IFB NUMBER: IFB 26-024/MR
IFB TITLE: Jack Brooks Regional Airport Airfield Lighting Rehabilitation
IFB DUE BY: 11:00 am CT, Wednesday, June 17, 2026
ADDENDUM NO.: 3
ISSUED (DATE): June 10, 2026

ADDENDUM NO. 3

Date: June 10, 2026
Project Name: Airfield Lighting Rehabilitation Project
Owner: Jefferson County
Jack Brooks Regional Airport
Owner Project No: Jefferson County Project IFB 26-024/MR
Garver Project No: 2400880

AIRFIELD LIGHTING REHABILITATION
LIGHTING INSTALLATION DETAILS 7

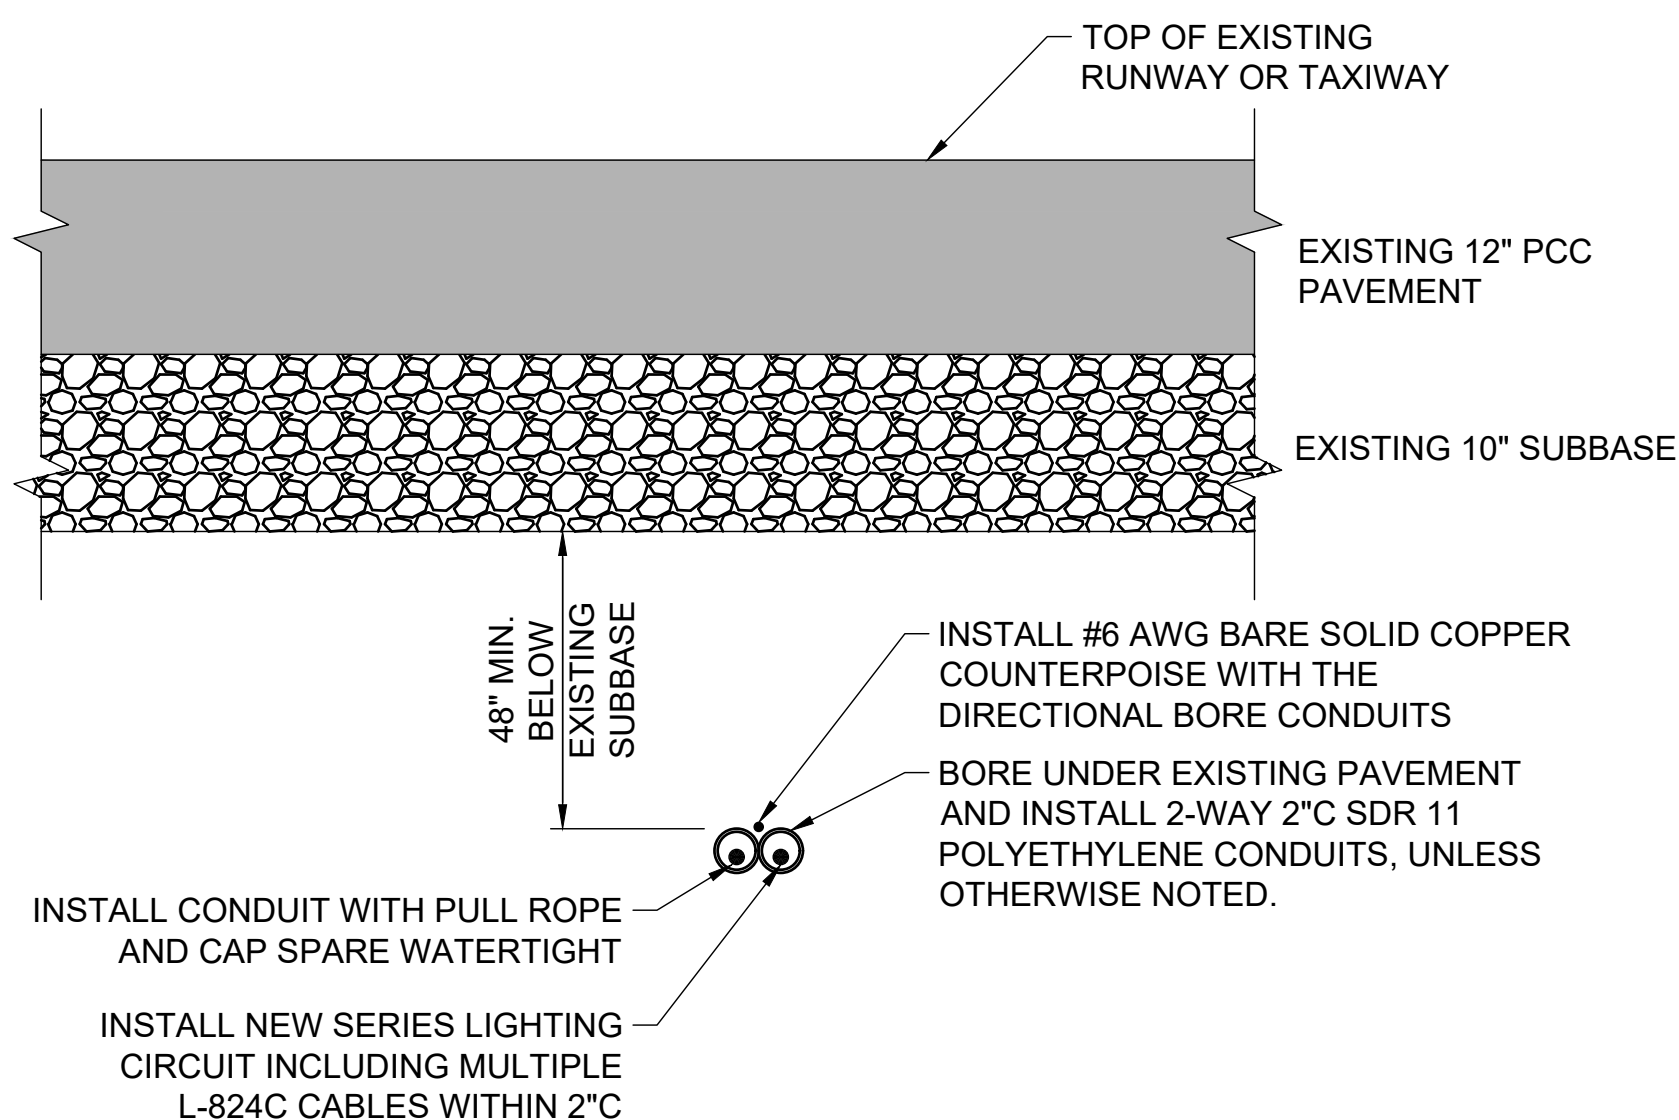
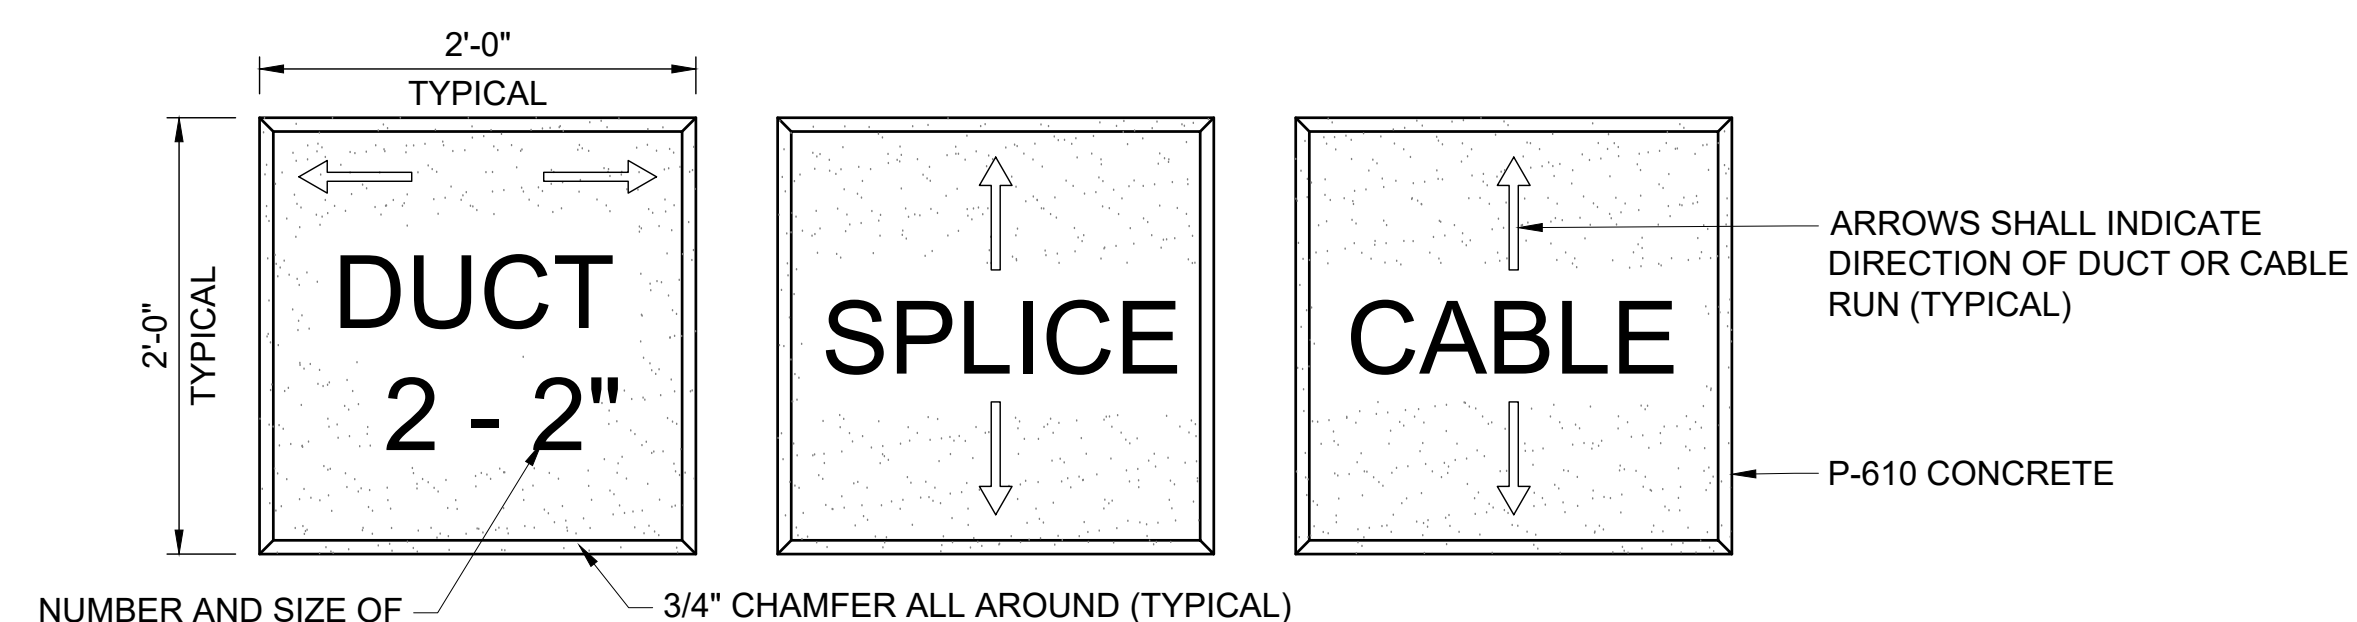
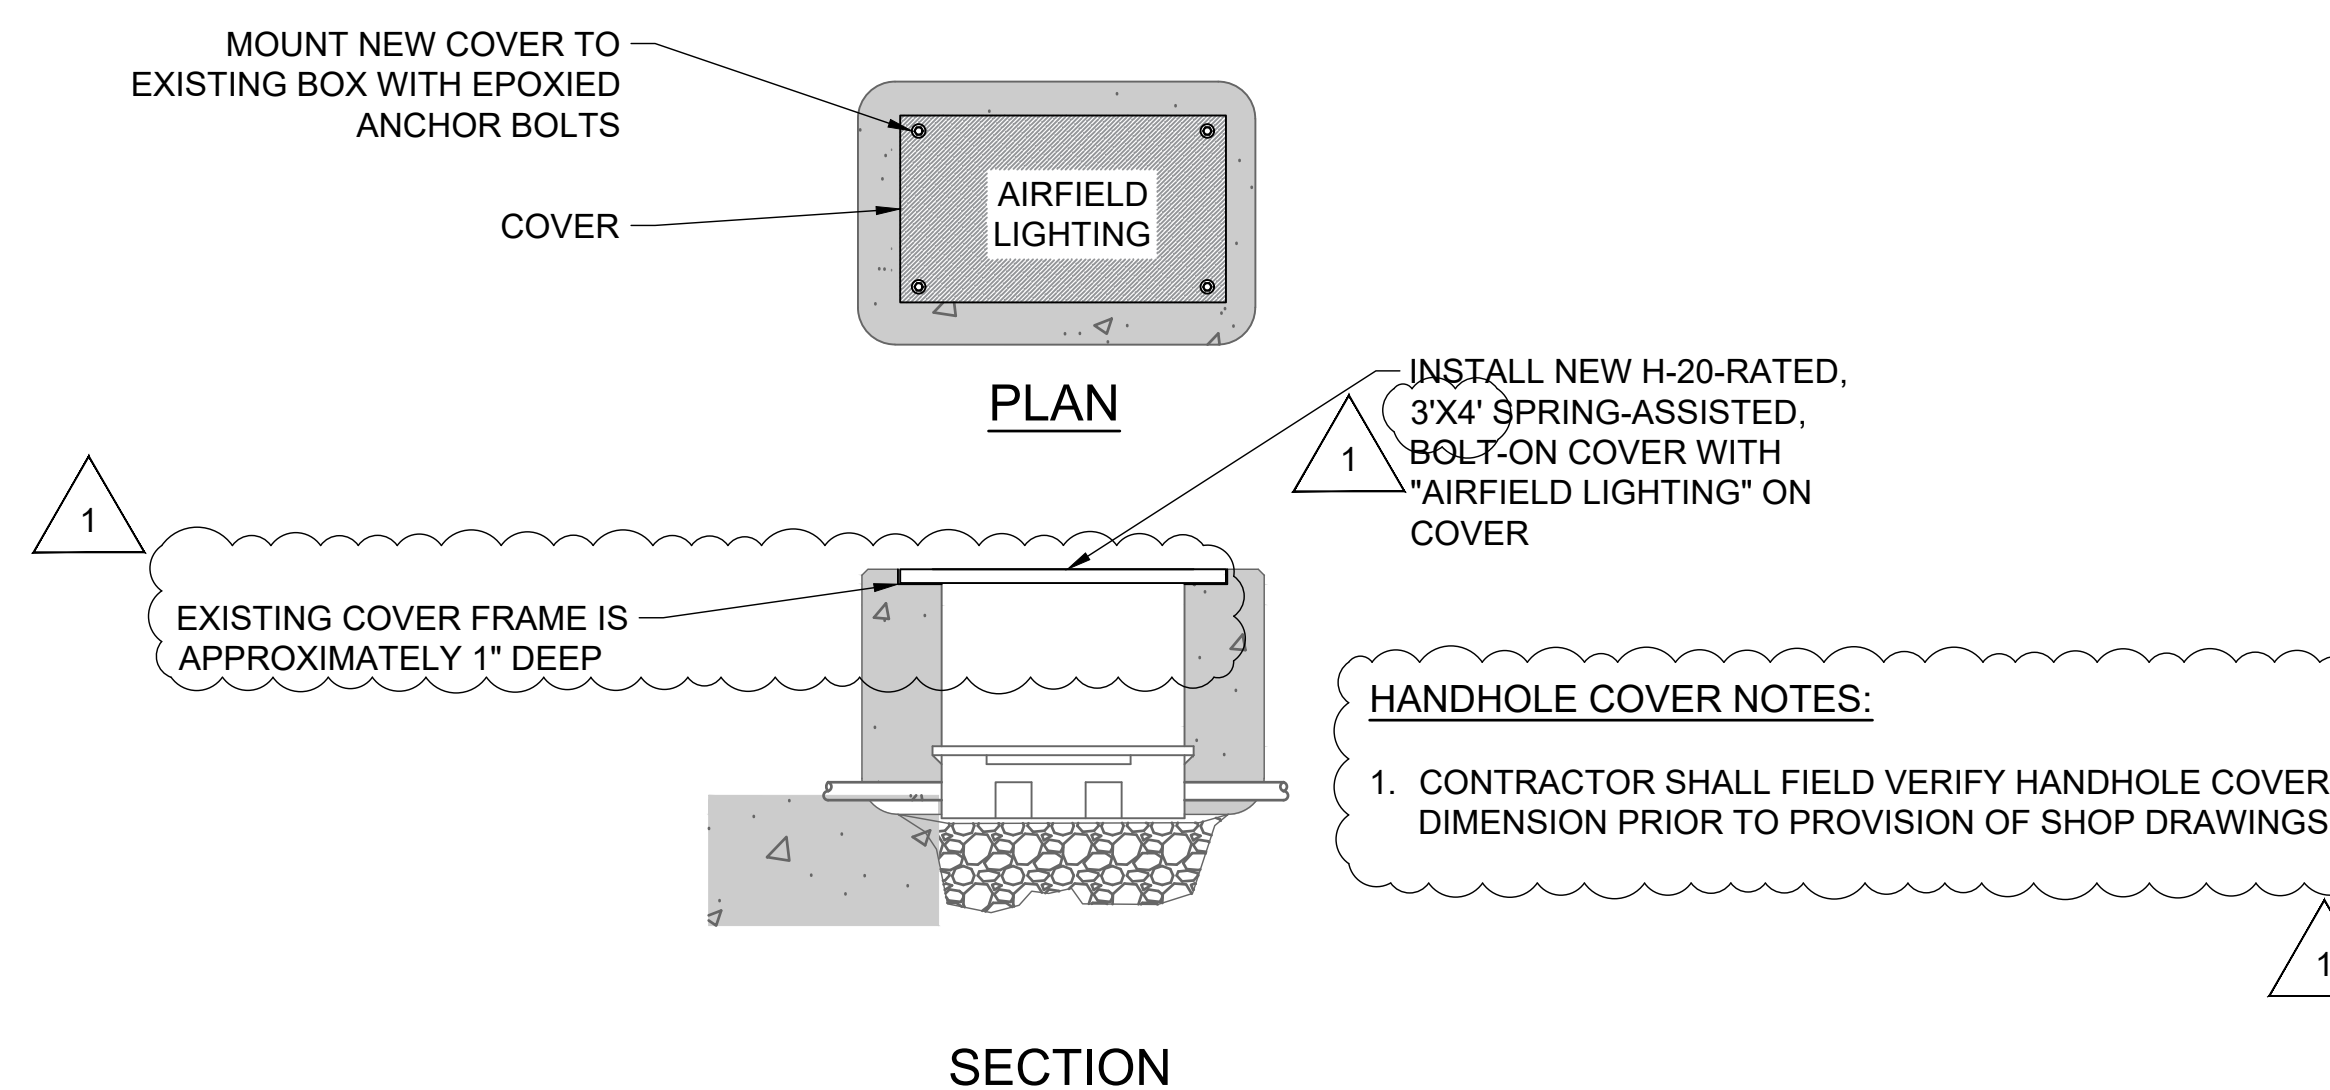
1. Remove the following drawings in their entirety, and replace with the same, attached hereto:
 - a. GC001 – Construction Safety & Phasing Notes 1
 - b. ED106 – Lighting Demolition Plan 6
 - c. EL507 – Lighting Installation Details 7

REV.	DATE	DESCRIPTION	BY
1	6/10/26	ADDENDUM NO. 3	MCL
